Motorola Solutions Technical Notification (MTN)

TITLE: APX6000BN /SRX2200BN / APX8000/XE/8500_radios cannot access a Type II Trunking site resulting in retries.

TECHNOLOGY: ASTRO Subscriber

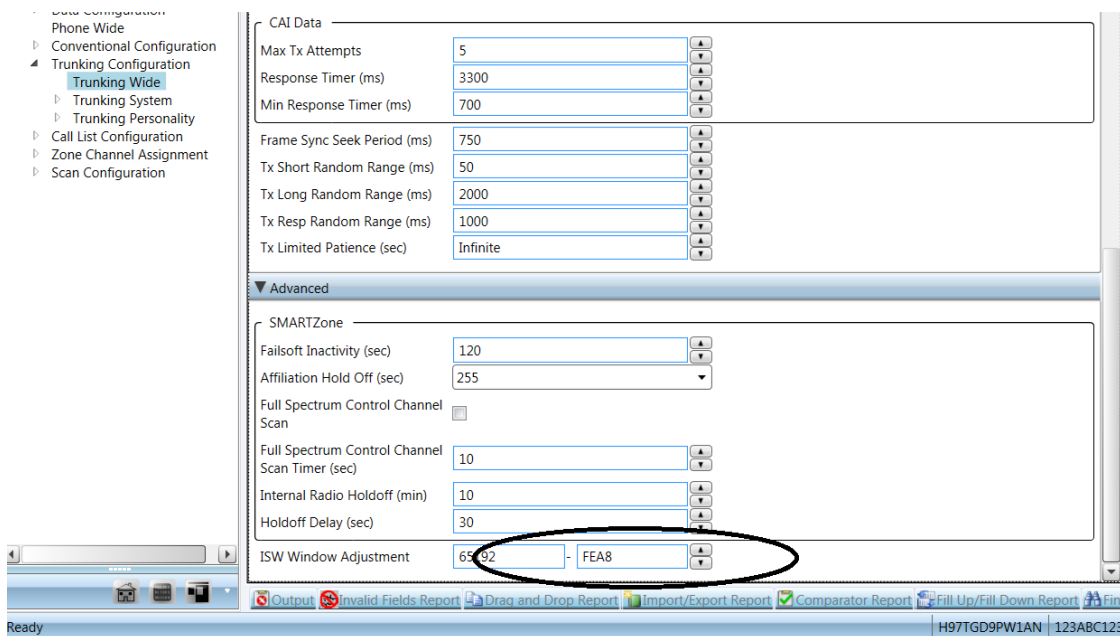
2. In the opened codeplug, navigate to Trunking Configuration->Trunking Wide. The last field at the bottom of the Trunking Wide Page is the ISW Window Adjustment Setting. **Verify the value for the 'Radio' is as listed below.** (see below):

Radio	Correct ISW Window Adjust Value
APX6000 BN Only Models	FEA0
SRX2200 BN Only Models	FEA0
APX8000 / XE	FEA8
APX8500	FEA8

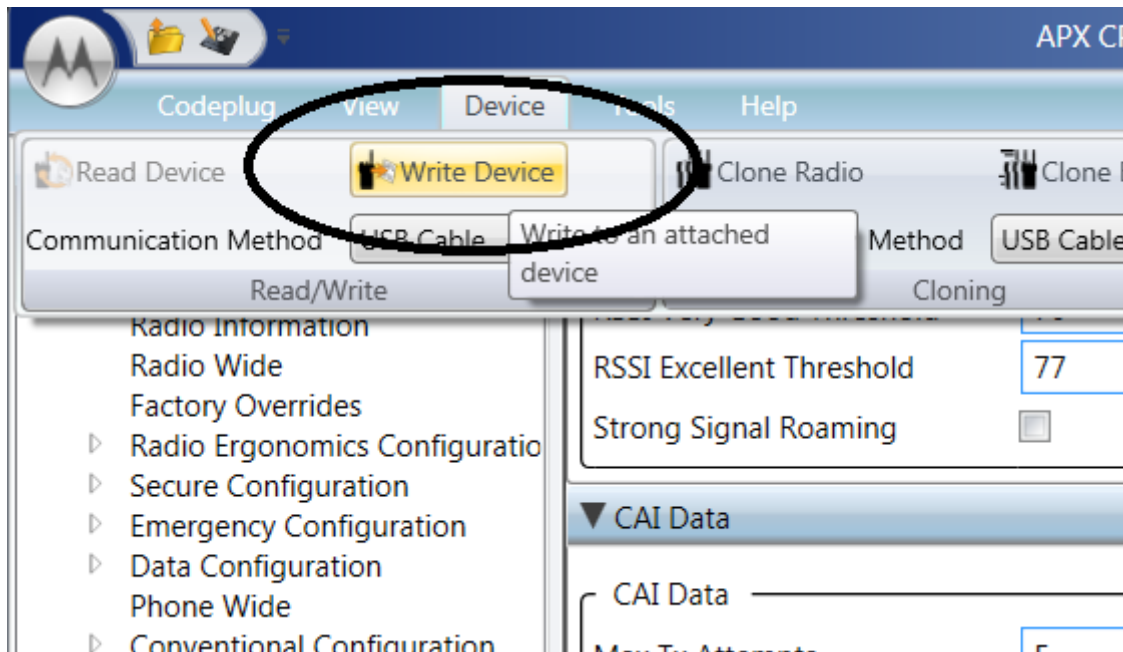
3. **Modify the ISW Window Adjustment hex value**, the second field on the right, **to the correct value if applicable.**

Radio	Correct ISW Window Adjust Value
APX6000 BN Only Models	FEA0
SRX2200 BN Only Models	FEA0
APX8000 / XE	FEA8
APX8500	FEA8
